UNITED STATES PATENT AND TRADEMARK OFFICE

APPLICATION NO.	FILING DATE	FIRST NAMED INVENTOR	ATTORNEY DOCKET NO.	CONFIRMATION NO.
09/846,889	05/01/2001	Thomas P. Feist	08CN08803C	5322
23413	7590	08/12/2004	EXAMINER	
CANTOR COLBURN, LLP			BERNATZ, KEVIN M	
55 GRIFFIN ROAD SOUTH			ART UNIT	
BLOOMFIELD, CT 06002			PAPER NUMBER

Office Action Summary	Application No.	Applicant(s)	
	09/846,889	FEIST ET AL.	
	Examiner	Art Unit	
	Kevin M Bernatz	1773

DETAILED ACTION

Figure 1: Landin et al. storage medium showing claimed limitations

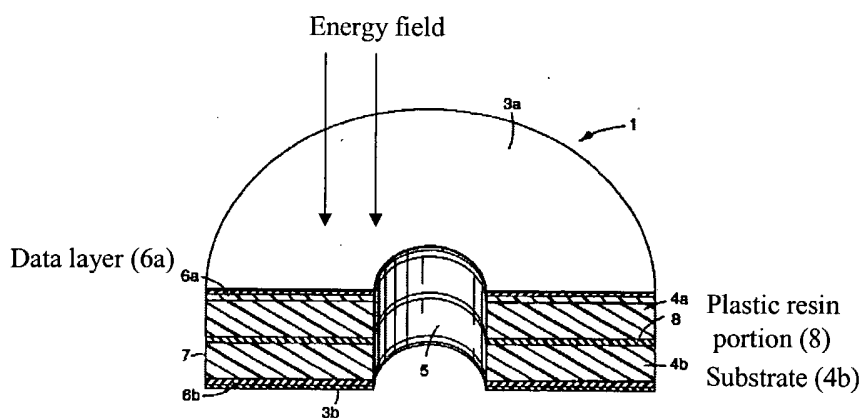
Regarding claims 1, 16, 17 and 24, Landin et al. disclose a method for retrieving data (*col. 2, line 66 bridging col. 3, line 8*), comprising rotating a storage media (*ibid*) comprising at least one plastic resin portion (see *Figure 1 below – element 8*) disposed between at least one data layer (*element 6a*) and a substrate (*element 4b*), directing an energy field (*col. 3, lines 1 – 8 and col. 11, lines 12 - 19*) at said storage media such that said energy field is incident upon the data layer before it can be incident upon the substrate (*since dual layered medium, necessarily happens whether one inverts the image or not¹*), and retrieving information from the data layer via said energy field (*col. 2, line 66 bridging col. 3, line 8*).

¹ – *If one argues that the energy field is from the opposite side, one could consider layer 6b the data storage layer and layer 4b the substrate and the energy field would still be incident on the data storage layer before being incident on the substrate.*

Figure 2 – Laminated substrate comprising 2 damping portions

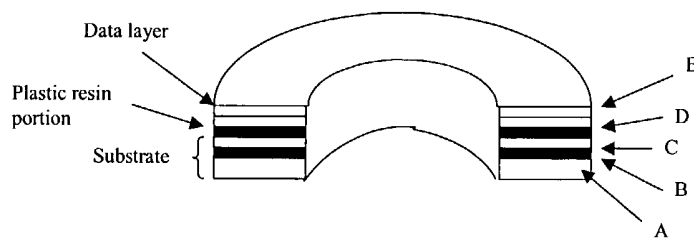
Regarding claim 32, the Examiner notes Figure 2 below, which represents an alternative embodiment disclosed by Landin et al. (*col. 5, lines 1 – 30 and Figures 2- 4*).

In the above Figure, layers A, B and C represent applicants' "substrate", wherein layer B comprises damping material. Layer D is a second layer of damping material and reads on applicants' claimed "plastic resin portion" with layer E being the data storage layer (see *Landin et al. Figures 2 and 3, wherein Landin et al. teach that the substrate can preferably be formed by simply laminating alternating layers of substrate + damping material in col. 5, lines 1 - 30*). The Examiner notes that Landin et al. teach that the damping material can comprise resins meeting applicants' claimed limitations (*col. 6, lines 63 – 67*).

Regarding claim 34, Landin et al. disclose that the substrate can further comprise metal (*as shown in Figure 2 above*) (*col. 5, lines 1 – 10 and 58 – 67*).

Regarding claims 42 and 45, Landin et al. disclose a “core” having a substantially constant thickness (*see Figure 2 above – element B*).

Regarding claim 47, Landin et al. disclose that the “core” shown in Figure 2 above (*layer B*) can include hollow cavities (*Landin et al. – Figure 4b and col. 10, lines 1 – 10*).

Regarding claims 53 and 55, Landin et al. disclose an insert meeting applicants’ claimed structural limitations (*Figure 2 above, wherein the “substrate” is element C, the plastic resin portion is element D, the data layer is element E, and the insert is element B*).

Figure 3: Illustration of “varied thickness” of substrate portion of Landin et al.

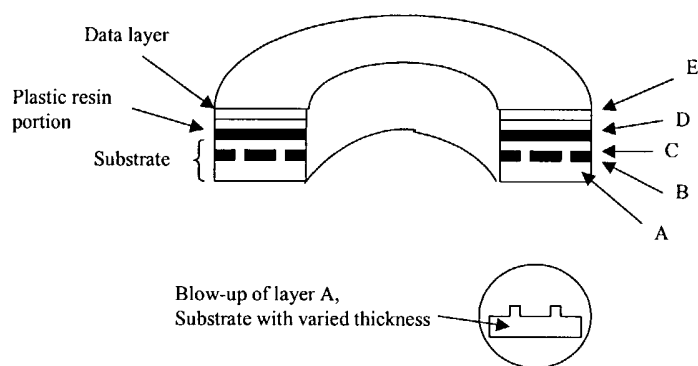
Regarding claim 40, Landin et al. disclose substrates comprising hollow portions (*Figure 4b*), which the Examiner deems would read on the limitation “having varied thickness” in the embodiment represented by Figure 2 above (*see Figure 3 below, element A*).

Regarding claims 43, 46, 48, 49 and 50, Landin et al. disclose a “core” having varied thickness including filled cavities (i.e. multiple portions comprising different materials – claims 49 and 50) (see *Figure 3 above, layer B*) wherein the “core” would result in rings meeting applicants’ claimed Markush limitation in claim 46.

Regarding claim 54, Landin et al. disclose an insert meeting applicants' claimed structural limitations (*Figure 3 above, wherein the "substrate" is element C, the plastic resin portion is element D, the data layer is element E, and the insert comprising a plurality of portions is element B*).
